**TOWN OF DAVIDSON  
DESIGN REVIEW BOARD  
216 S Main St, Davidson, NC**

**February 15, 2017**

**Agenda Title:** DUMC Columbarium

**Town of Davidson, NC  
Design Review Board: Staff Analysis  
Project Manager: Chad Hall  
February 15, 2016**

CONCEPTUAL  
SITE PLAN

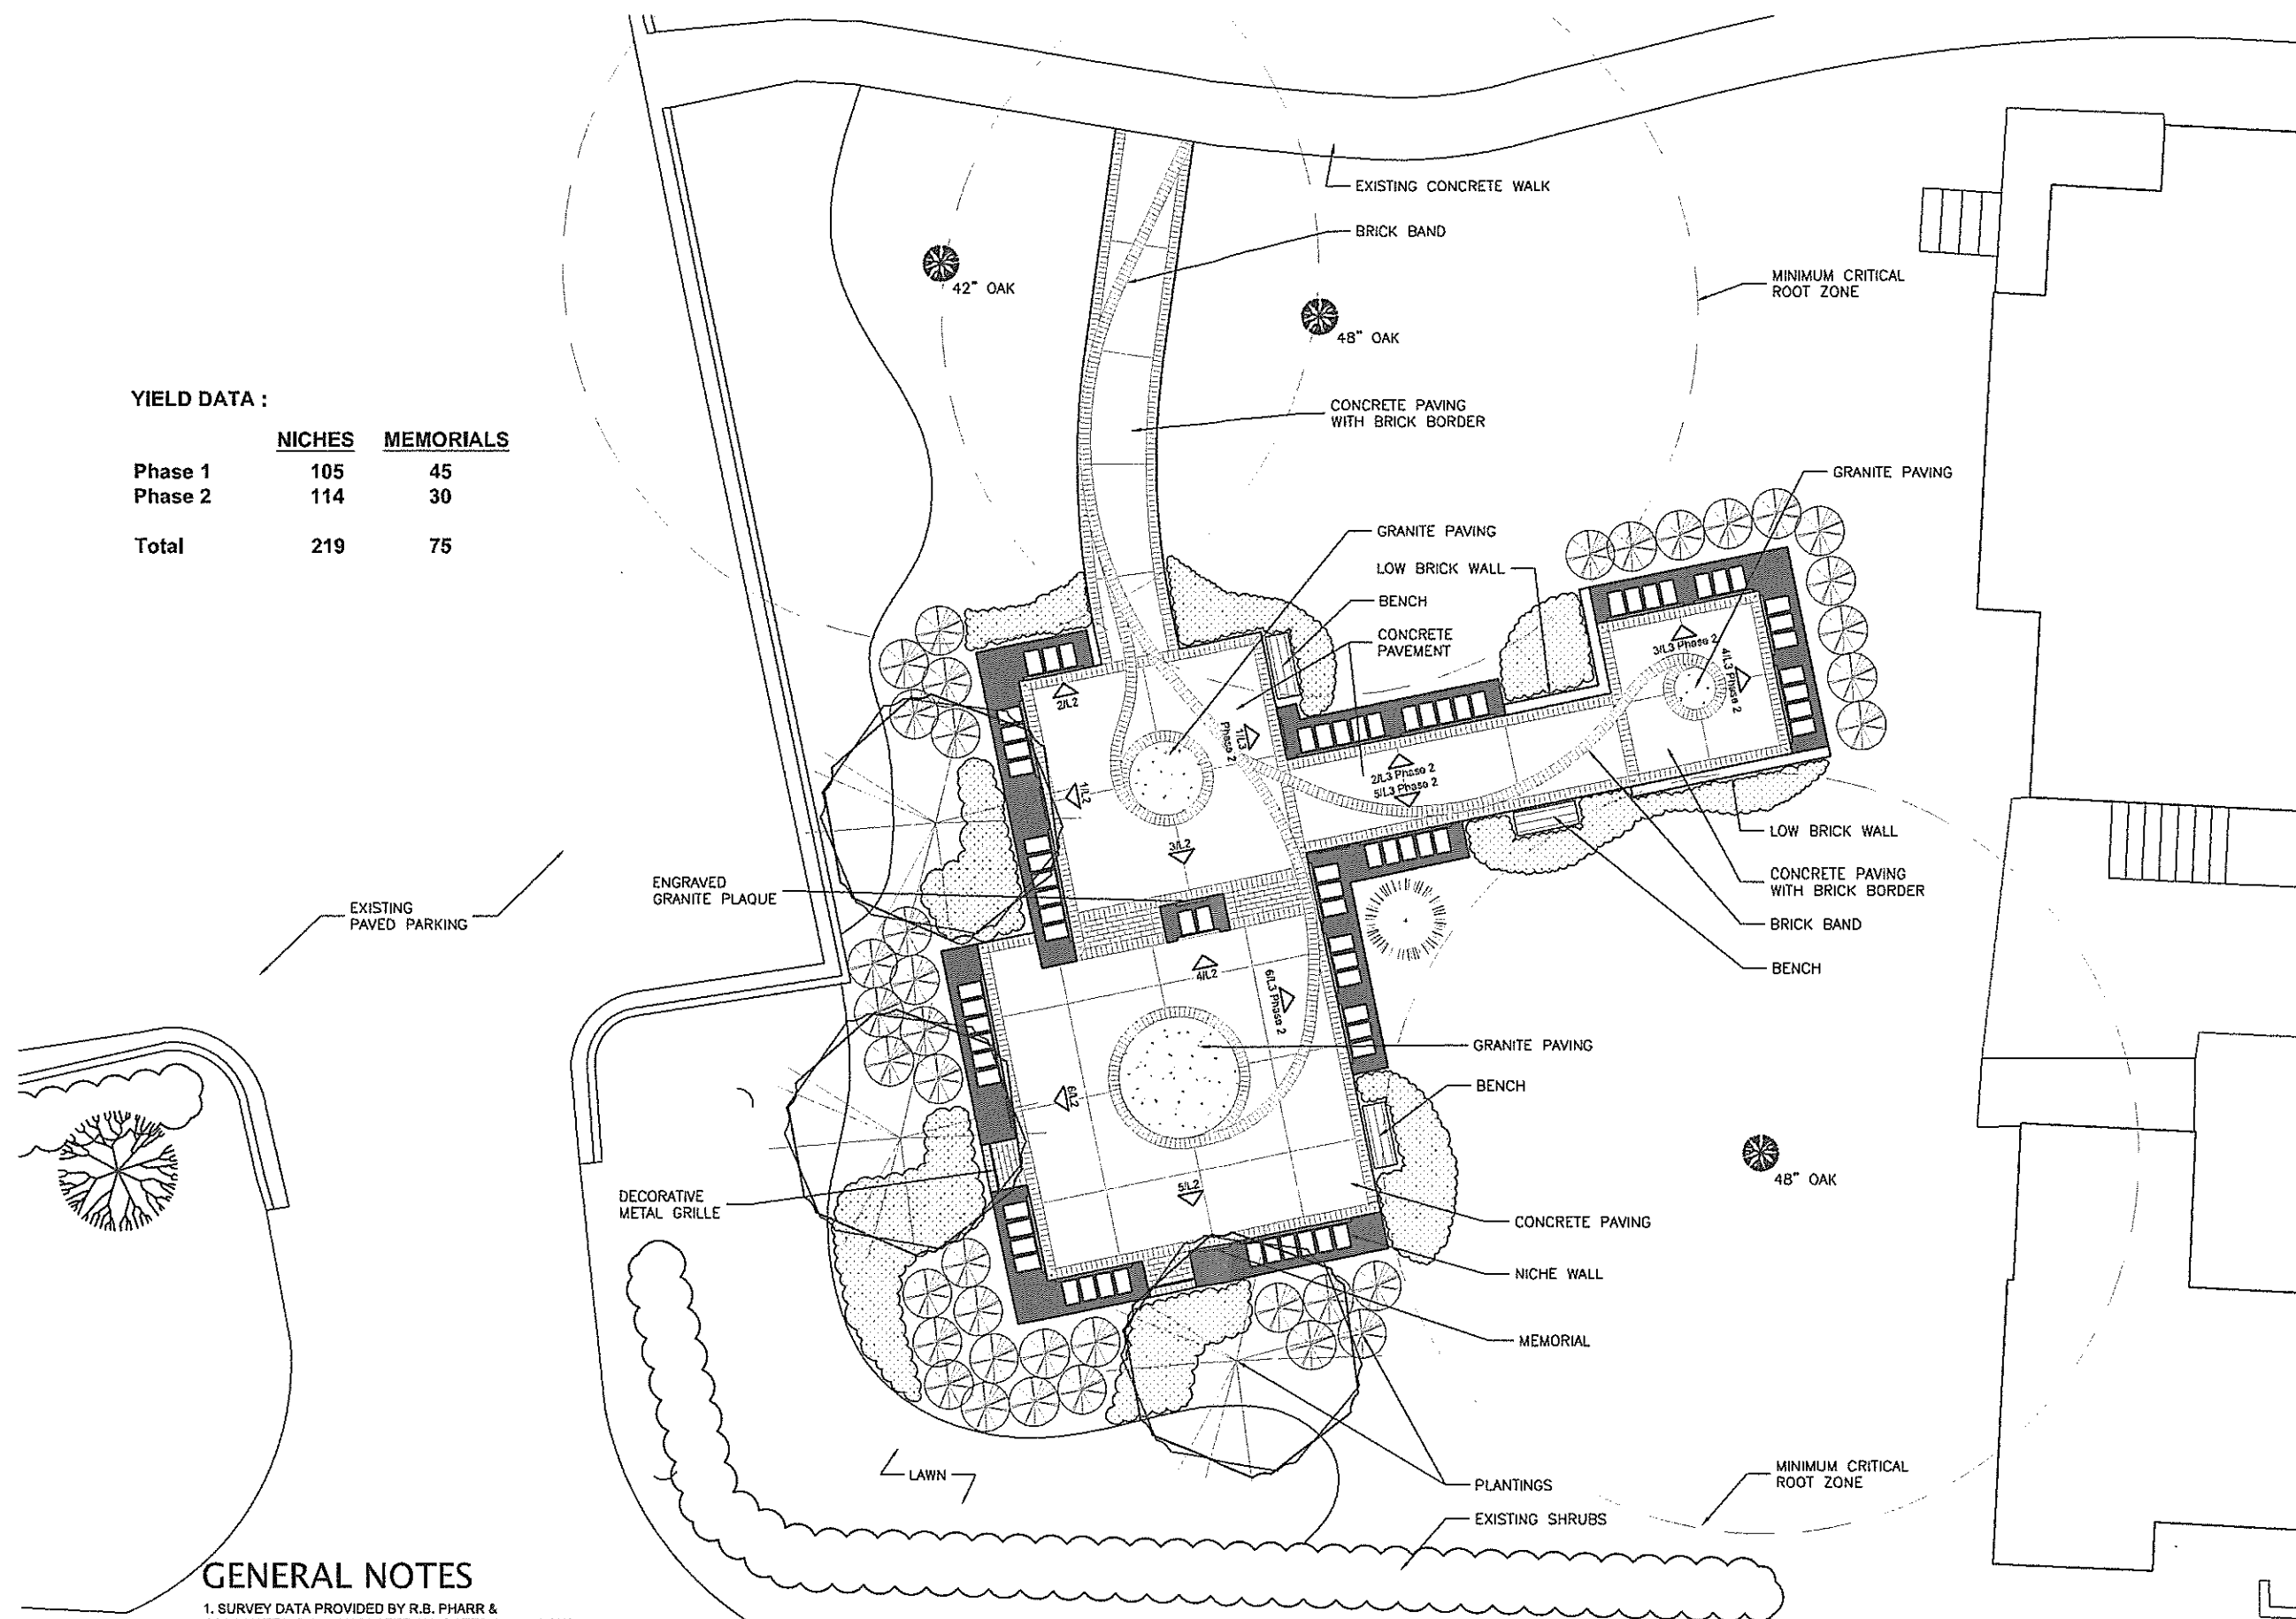
The applicant proposes a columbarium in the rear yard on a lot owned by Davidson United Methodist Church, adjacent to their primary parcel. The property is located on the northwest corner of South Street at Cathey Street.

The proposed columbarium site, including walkways and the niche wall structures, is approximately 1,670 square feet and will include 219 niches and 75 memorials once completed over two phases of construction. Phase one primarily consists of constructing the easternmost and southernmost niche walls. All walkways will be constructed in this first phase.

Materials for the niches are listed as brick walls with cast stone caps. Brick is to closely match the main church building. The niches will be covered with granite (color not specified).

Materials of the walkway include concrete with a brick binding. There is also a decorative brick element that serpentine through the design and resolves at central areas with granite highlighted in the center.

The proposed columbarium meets all dimensional requirements of the Davidson Planning Ordinance.
